23/65-97C 9 High St. Brookeville
(Brookeville Historic District)

SUBJECT: Historic Area Work Permit

HISTORIC PRESERVATION COMMISSION STAFF REPORT

PROPOSAL: Remove existing porch;
construct new front porch.

Alternative #1
OPTION B

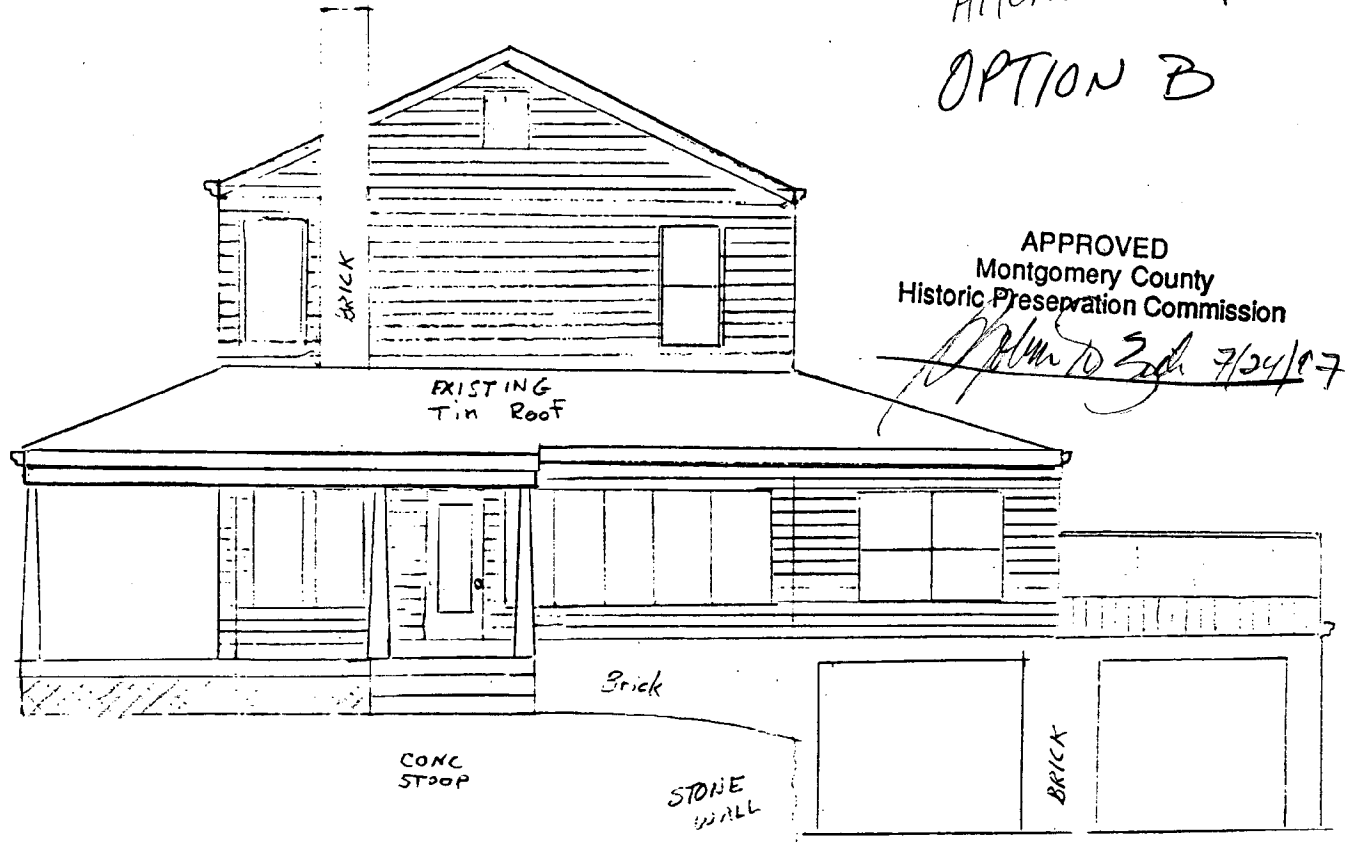
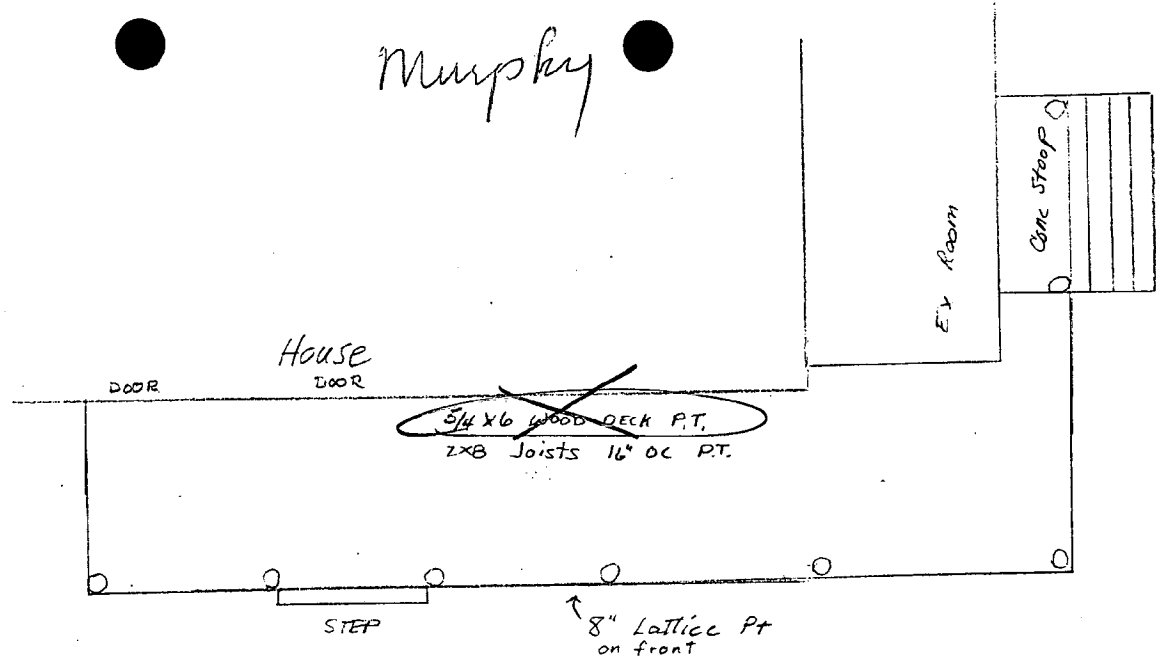
- (1) Conform to Alternative #1, OPTION B
- (2) Porch Railing, as required by County Code, to extend the full length of the porch & utilize inset pickets.
- (3) Porch Floor to use T- & - G flooring running perpendicular to house
- (4) All new wood surfaces to be painted
- (5) Applicant to provide permit set of drawings to HPC staff for review & stamp, which note the specifications on columns, porch ceiling, floor, & railing.

ALTERNATIVE 1
OPTION B

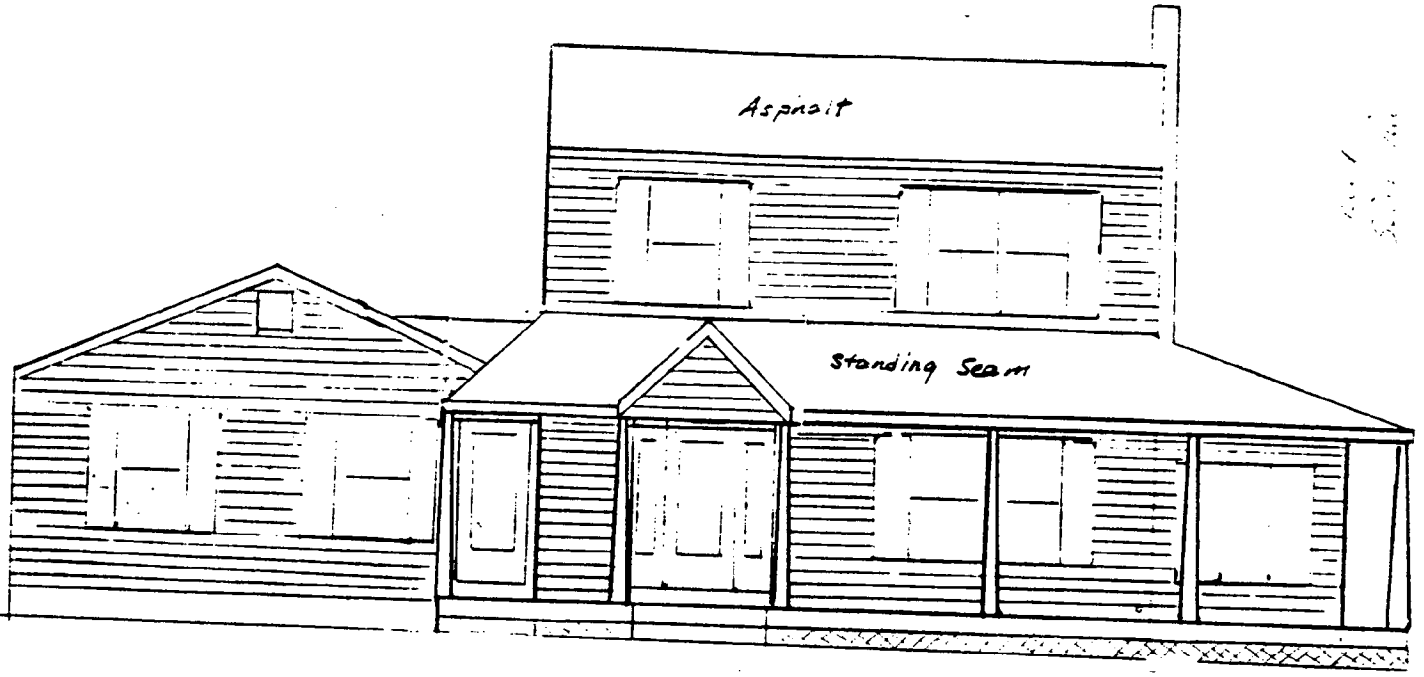
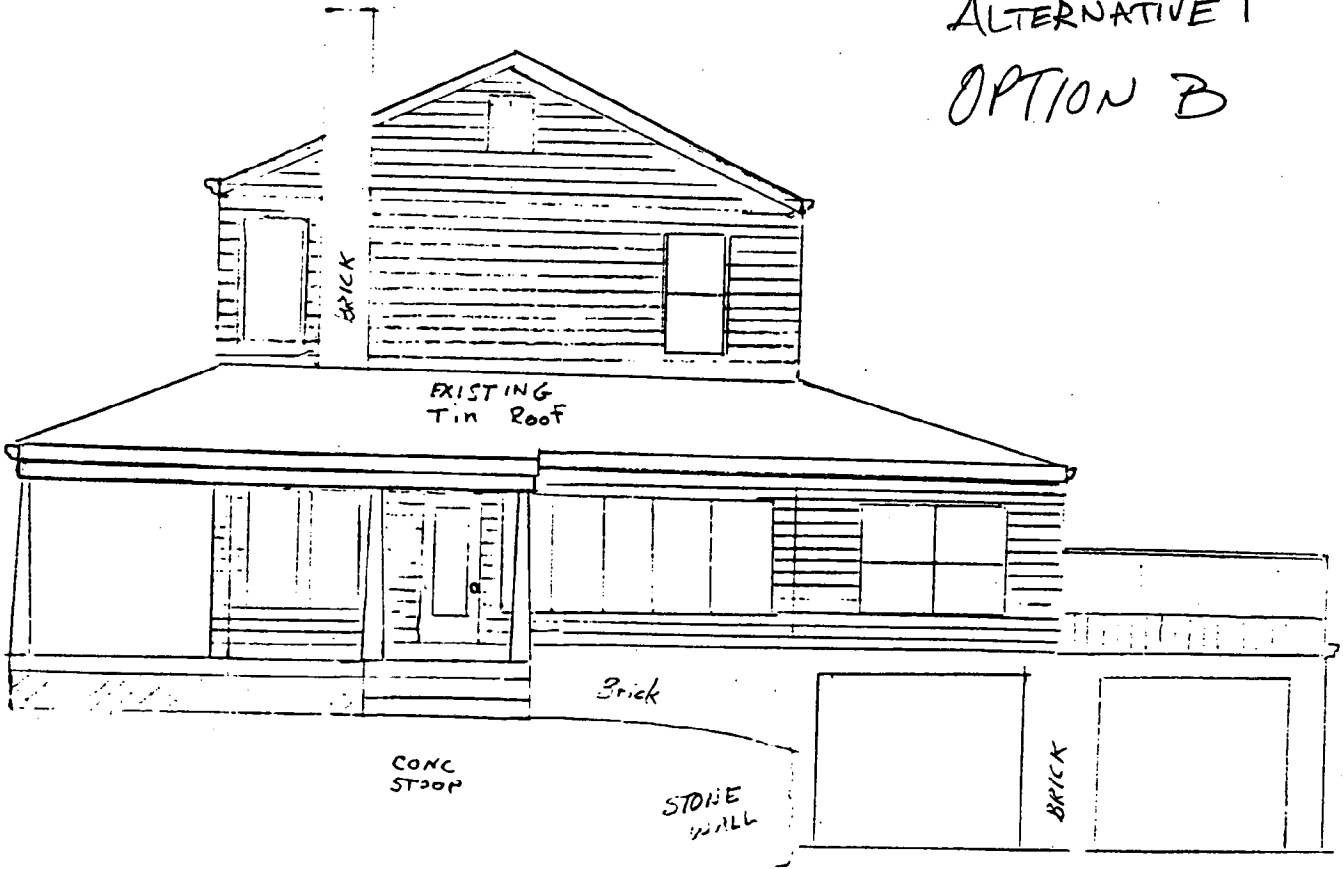
Option B: Build porch floor in the more typical configuration, with exterior steps leading up to the porch at the dripline. Use 2" x 6" pressure-treated lumber for the flooring. (Circle 7)

For this reason, staff feels that Alternative 1, Option B is the preferred proposal. Staff also feels that there should be a continuous porch railing (except for the openings for each doorway). In this way, the use of pressure-treated wood for the porch decking would not be apparent from the public right-of-way, and there would be one porch railing treatment even though the grade changes across the site. **Staff notes, however, that the applicant could utilize traditional tongue-and-groove flooring for a fully covered porch, and this would be most consistent with porch construction in general.** Staff is aware that such flooring requires painting for weather protection because such thin wood does not come pressure-treated. The applicant could, however, extend the life of this porch decking by the application of a paintable water-repellent preservative prior to painting the floor with a porch paint.

As the applicant's proposal does not include the installation of a porch railing, staff notes that the porch should have a railing to address the county code requirements. The railing should utilize simple pickets which are inset to the top and bottom rail so as to sit within the plane of the top and bottom rails.

1. The new porch will conform to Alternative #1, Option B in the application .
2. The porch railing, if required by County Code, will extend the full length of the porch, and utilize inset pickets.
3. The porch floor will utilize typical tongue-and-groove flooring running perpendicular to the house.
4. All new wood surfaces will be painted.
5. Before application for a building permit at DPS, the applicant will provide detailed drawings of the proposed porch, including specifications for the porch columns, the porch ceiling, the porch floor, and the porch railing for HPC staff to review and stamp.

ALTERNATIVE 2
OPTION A

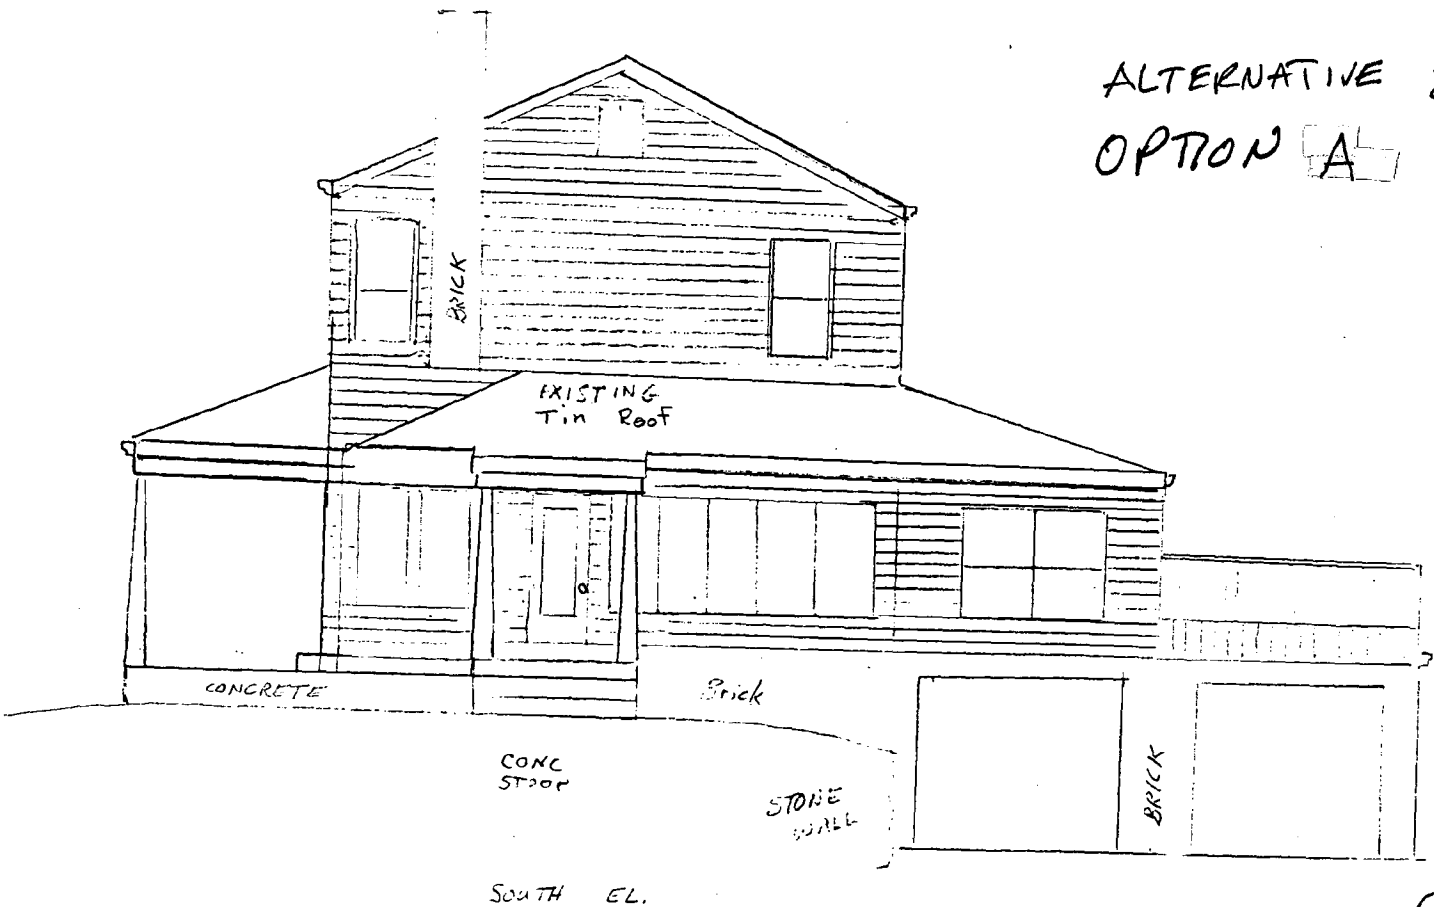
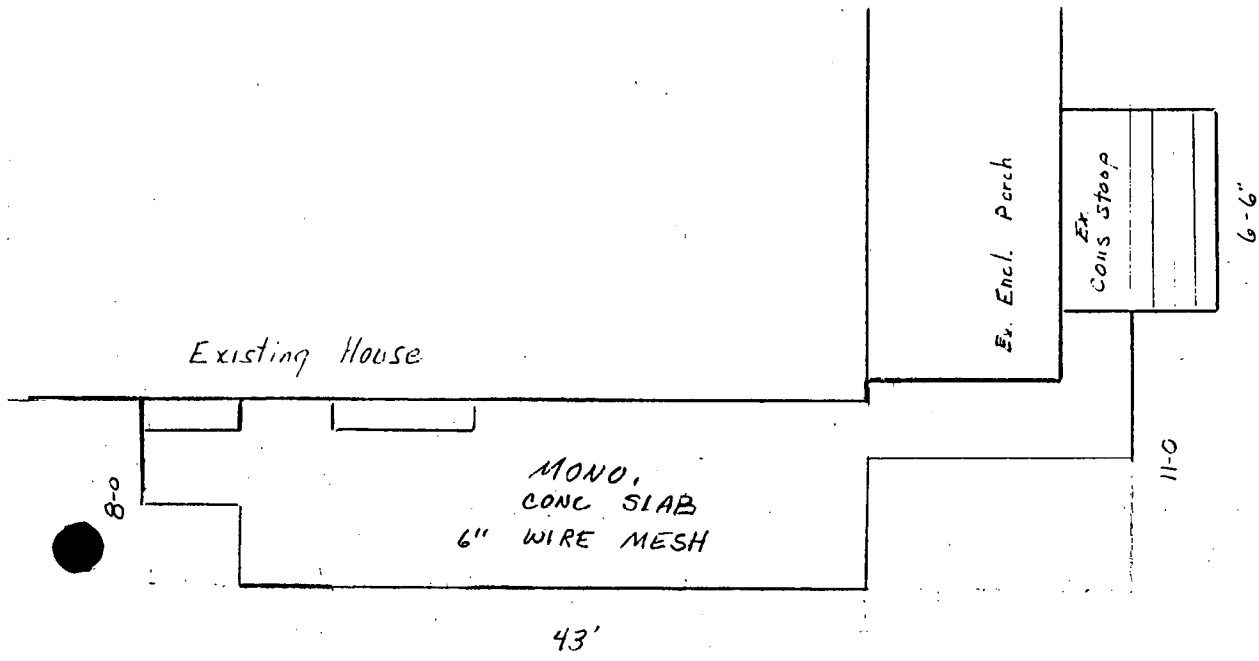
Option A: Pour a concrete slab on grade, and construct steps at each entrance to accommodate the grade at the doorway. (See Circle 9)

With Option A, the applicant proposes to use a concrete slab under the porch roof. This is not a typical configuration for several reasons. 1) Historically, the porch roof provided protection from sun and rain for both the porch decking and for the people utilizing the porch. Poured concrete is a material which does not have to be shielded from the weather, and has been more typically used for patios, or walks and driveways; 2) In addition, the use of a slab on grade, would give rise to another atypical situation of having individual steps at each doorway of varying heights to accommodate the grade changes; 3) The proportions of the columns would be too tall in relation to the front door; and 4) The use of a concrete slab at the front of the house is also inconsistent with the wood frame construction and with wooden porch construction in general. **For these reasons, staff does not support Option A of either proposed Alternative.**

ALTERNATIVE 2
OPTION B

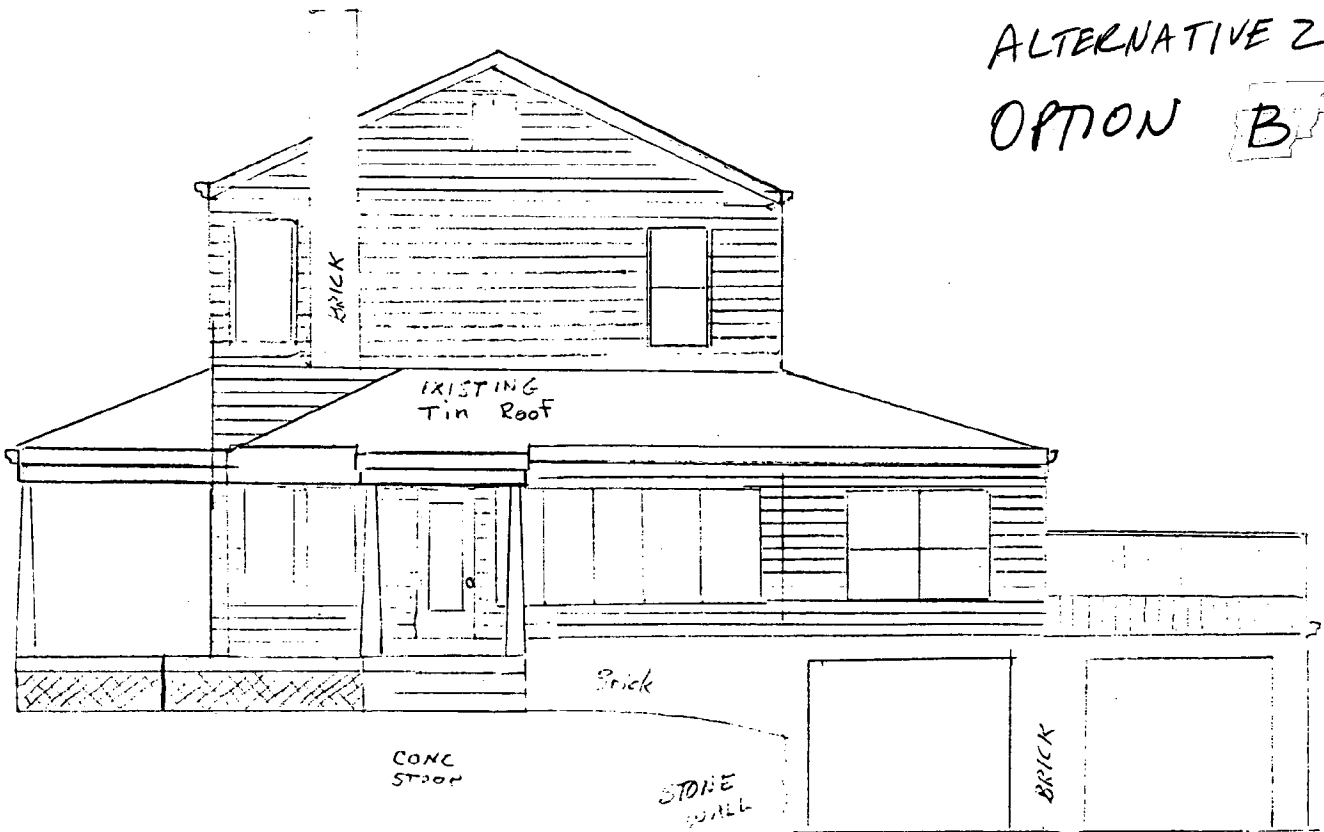
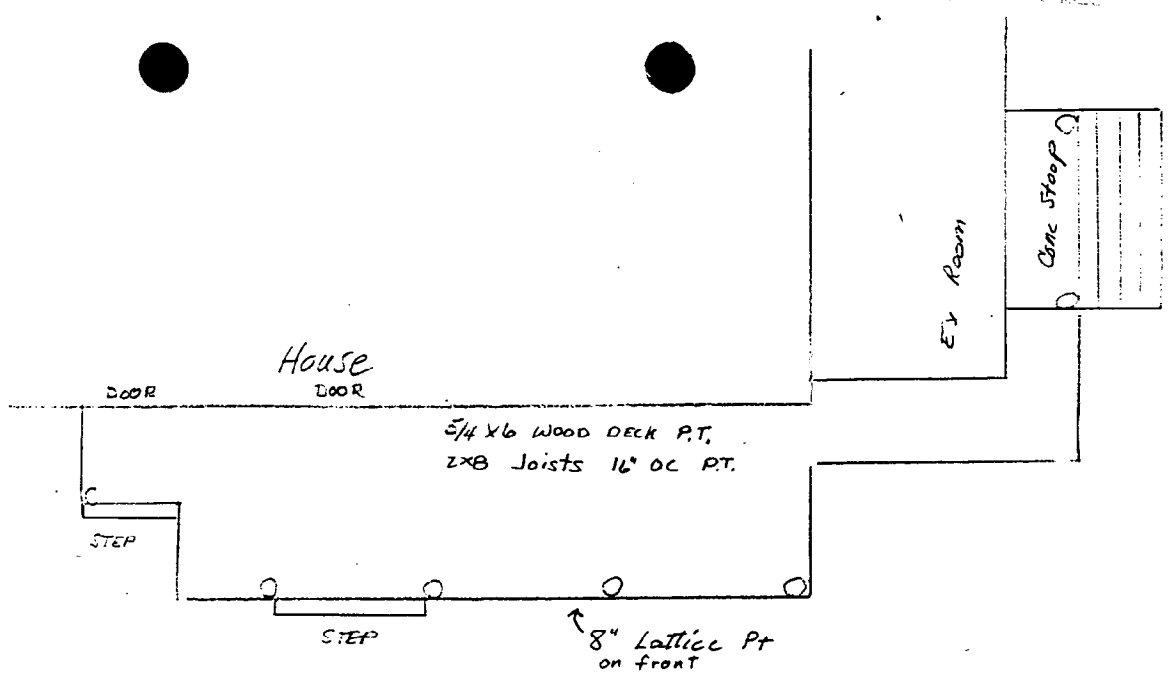
Option B: Build porch floor in the more typical configuration, with exterior steps leading up to the porch at the dripline. Use 2" x 6" pressure-treated lumber for the flooring. (See Circle 11)

Alternative 2 is an interesting compromise solution by maintaining separate porch roofs for each entrance, while providing a connection to all three doorways with a continuous porch floor. Staff feels that the proposed use of pressure-treated wood flooring makes sense in terms of the use of the unroofed sections. However, the proposal calls for the porch construction without any railing at all. According to the County codes, the applicant would need a railing for a portion of the porch because the grade is 30" or greater. It would be awkward to have a railing only at the section closest to the sun porch, and especially if there was a railing at the corner section between porch roofs.
